Notes prepared by Jeremy Chrzan, PE during the May 6, 2024 walk audit from Central High School

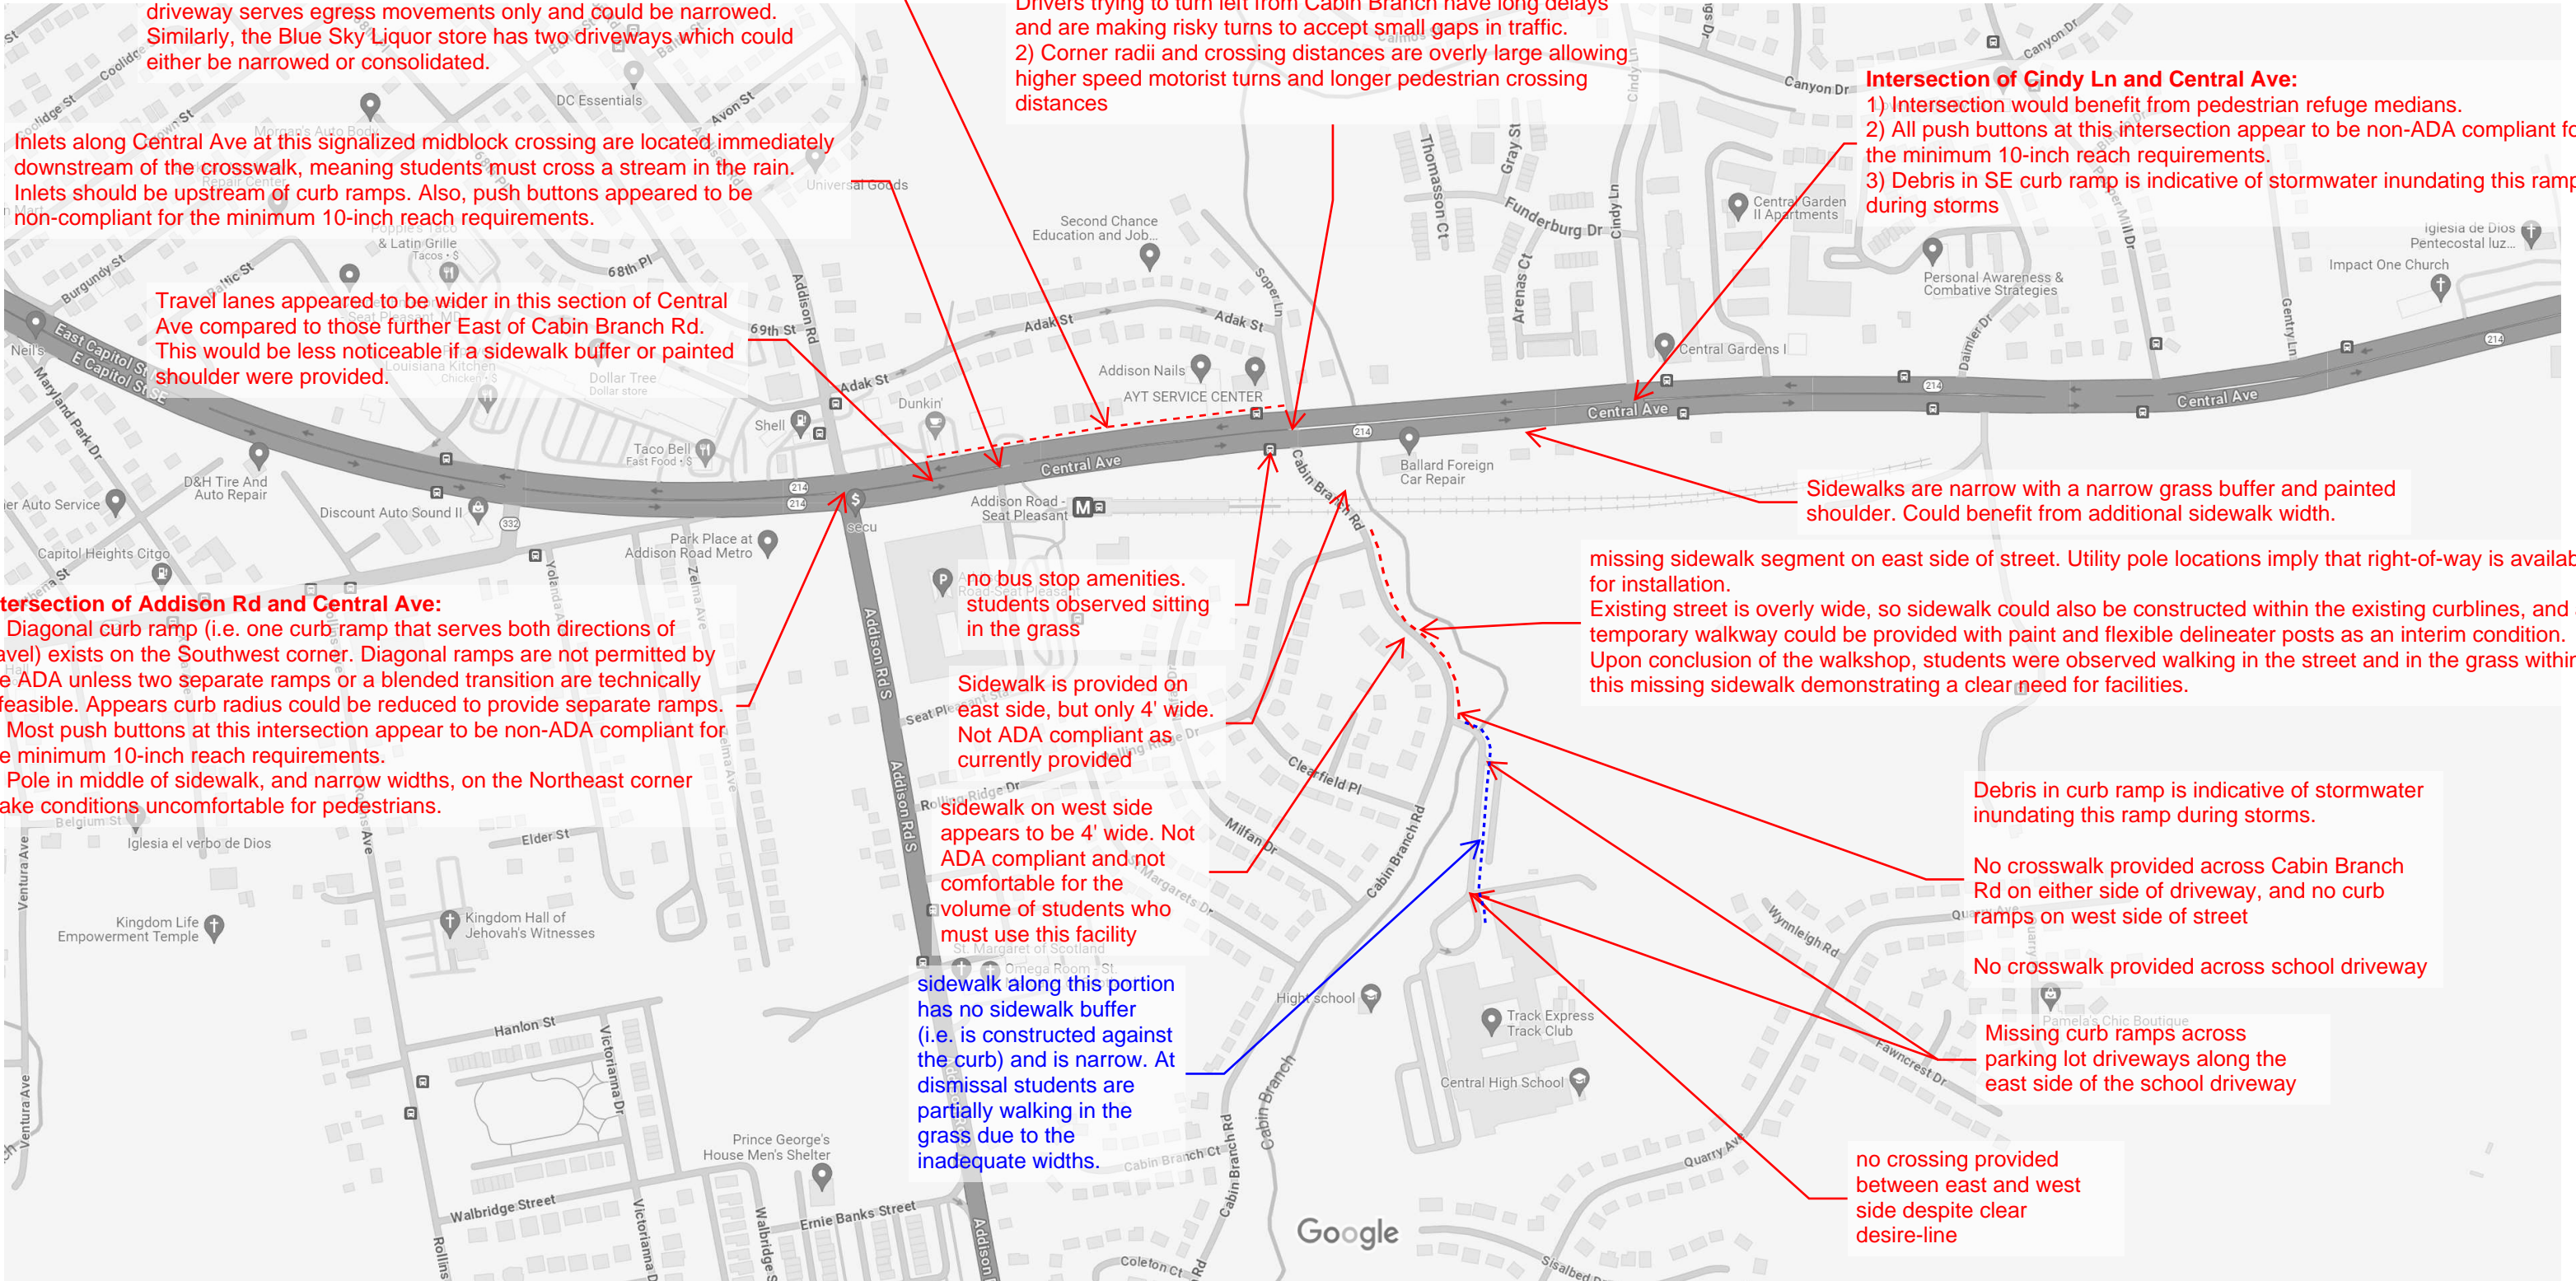
Sidewalk includes no buffer from curbline and no painted shoulder resulting in uncomfortable walking conditions. Driveway aprons to non-existent driveways are prevalent, creating uncomfortable walking conditions and drainage issues. Some existing driveways appear unnecessarily large. For example, the Dunkin' exit driveway serves egress movements only and could be narrowed. Similarly, the Blue Sky Liquor store has two driveways which could either be narrowed or consolidated.

Inlets along Central Ave at this signalized midblock crossing are located immediately downstream of the crosswalk, meaning students must cross a stream in the rain. Inlets should be upstream of curb ramps. Also, push buttons appeared to be non-compliant for the minimum 10-inch reach requirements.

Travel lanes appeared to be wider in this section of Central Ave compared to those further East of Cabin Branch Rd. This would be less noticeable if a sidewalk buffer or painted shoulder were provided.

Intersection of Cabin Branch/Soper Ln & Central Ave:

- 1) No crossing provided across Central Ave despite presence of bus stop on North side. Location would benefit from signalization. Drivers trying to turn left from Cabin Branch have long delays and are making risky turns to accept small gaps in traffic.
- 2) Corner radii and crossing distances are overly large allowing higher speed motorist turns and longer pedestrian crossing distances

Intersection of Cindy Ln and Central Ave:

- 1) Intersection would benefit from pedestrian refuge medians.
- 2) All push buttons at this intersection appear to be non-ADA compliant for the minimum 10-inch reach requirements.
- 3) Debris in SE curb ramp is indicative of stormwater inundating this ramp during storms

Sidewalks are narrow with a narrow grass buffer and painted shoulder. Could benefit from additional sidewalk width.

missing sidewalk segment on east side of street. Utility pole locations imply that right-of-way is available for installation. Existing street is overly wide, so sidewalk could also be constructed within the existing curblines, and a temporary walkway could be provided with paint and flexible delineator posts as an interim condition. Upon conclusion of the walkshop, students were observed walking in the street and in the grass within this missing sidewalk demonstrating a clear need for facilities.

Intersection of Addison Rd and Central Ave:

- 1) Diagonal curb ramp (i.e. one curb ramp that serves both directions of travel) exists on the Southwest corner. Diagonal ramps are not permitted by the ADA unless two separate ramps or a blended transition are technically infeasible. Appears curb radius could be reduced to provide separate ramps.
- 2) Most push buttons at this intersection appear to be non-ADA compliant for the minimum 10-inch reach requirements.
- 3) Pole in middle of sidewalk, and narrow widths, on the Northeast corner make conditions uncomfortable for pedestrians.

no bus stop amenities. students observed sitting in the grass

Sidewalk is provided on east side, but only 4' wide. Not ADA compliant as currently provided

sidewalk on west side appears to be 4' wide. Not ADA compliant and not comfortable for the volume of students who must use this facility

sidewalk along this portion has no sidewalk buffer (i.e. is constructed against the curb) and is narrow. At dismissal students are partially walking in the grass due to the inadequate widths.

Debris in curb ramp is indicative of stormwater inundating this ramp during storms.

No crosswalk provided across Cabin Branch Rd on either side of driveway, and no curb ramps on west side of street

No crosswalk provided across school driveway

Missing curb ramps across parking lot driveways along the east side of the school driveway

no crossing provided between east and west side despite clear desire-line
